**CITY OF DULUTH
STAIR REPLACEMENT PROJECT
PARK POINT BEACH HOUSE
5000 Minnesota Avenue
Duluth, Minnesota**

The following addendum shall be appended to and shall become a part of the plans and specifications for the Stair Replacement Project, Park Point Beach House, 5000 Minnesota Avenue, Duluth, Minnesota.

ADDENDUM #1

PLAN & DETAILS

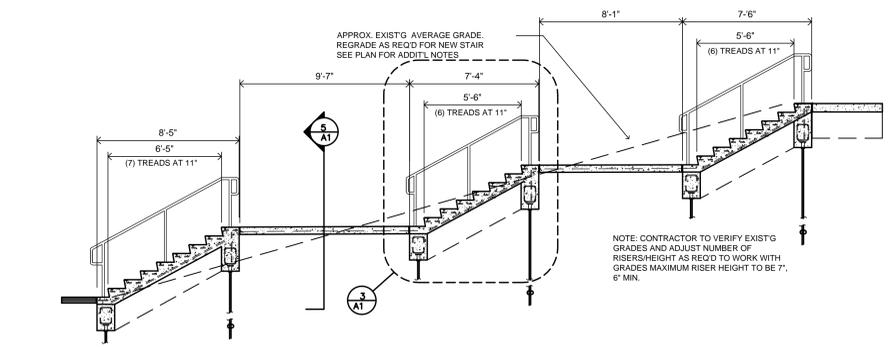
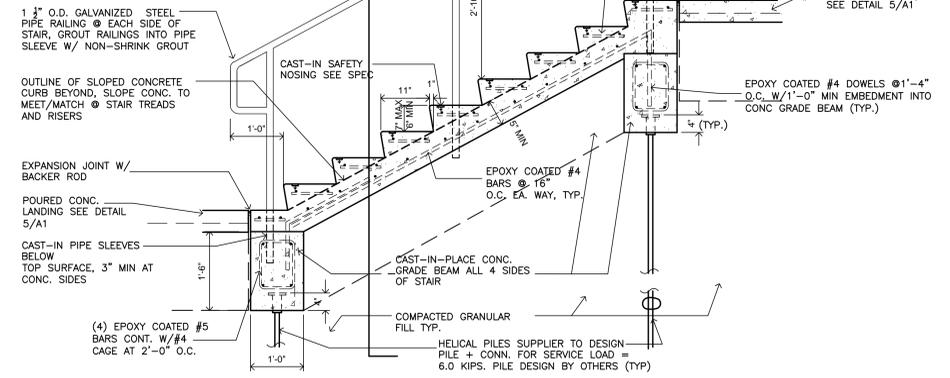
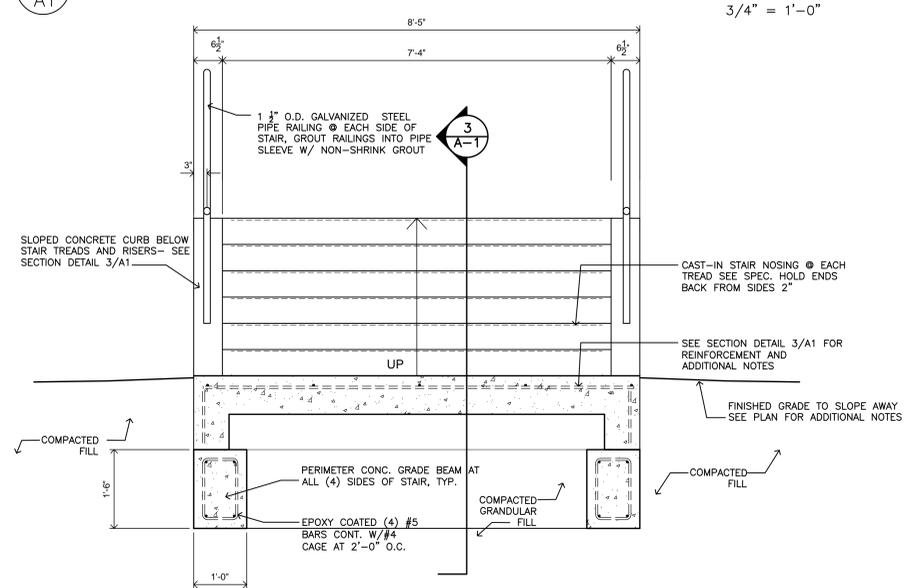
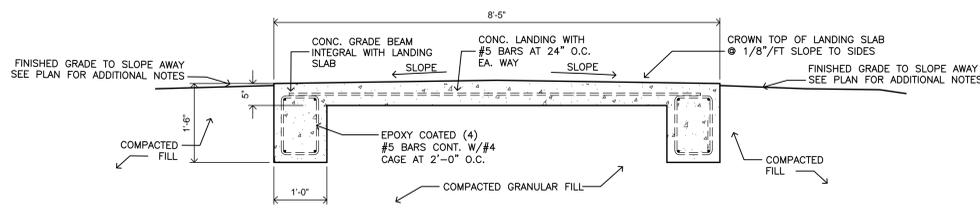
1. Section 03 20 00 – Concrete Reinforcement
All cast in reinforcement bars to be epoxy coated.
2. Plans: Delete Plan Sheet A1 dated 3/5/13 and replace with revised plan sheet R1 dated 11/15/13.

This plan sheet revises the foundation to a helical pile system. Refer to foundation notes on plans.

- FOUNDATIONS**
- FROST DEPTH TO BE 6'-0" TO BOTTOM OF ALL PERIMETER AND EXTERIOR FOUNDATIONS.
 - FRAME STRUCTURE SHALL BE PILE SUPPORTED BY HELICAL PILES.

- HELICAL PILES:
 - SEE PLANS FOR DESIGN (WORKING) LOAD ON EACH HELICAL PILE.
 - THE CONTRACTOR SHALL FURNISH AND INSTALL HELICAL SCREW PILES AND CONNECTIONS THAT WILL DEVELOP THE REQUIRED VERTICAL LOAD CAPACITIES, TENSION OR COMPRESSION, SHOWN ON THE DRAWINGS.

- ALL COMPONENTS SHALL BE HOT DIPPED GALVANIZED IN ACCORDANCE TO ASTM A 153.
 - THE OVERALL LENGTH AND INSTALLED TORQUE OF THE HELICAL SCREW PILES SHALL BE SUCH THAT THE REQUIRED IN-SOIL CAPACITY IS DEVELOPED BY END BEARING ON THE HELIX PLATES IN AN APPROPRIATE STRATA. AT A MINIMUM, THE TOP OF HELIX SHALL BE LOCATED BELOW THE FROST DEPTH.

- ALL PILES SHALL BE STEEL CONFORMING TO ASTM A36 WITH SIZE AS REQUIRED BY SUPPLIER.
 - PILE INSTALLATION SHALL BE MONITORED BY A QUALIFIED GEOTECHNICAL ENGINEER. THE DRIVING CRITERIA MAY BE MODIFIED TO SUIT THE SITE CONDITIONS ENCOUNTERED.
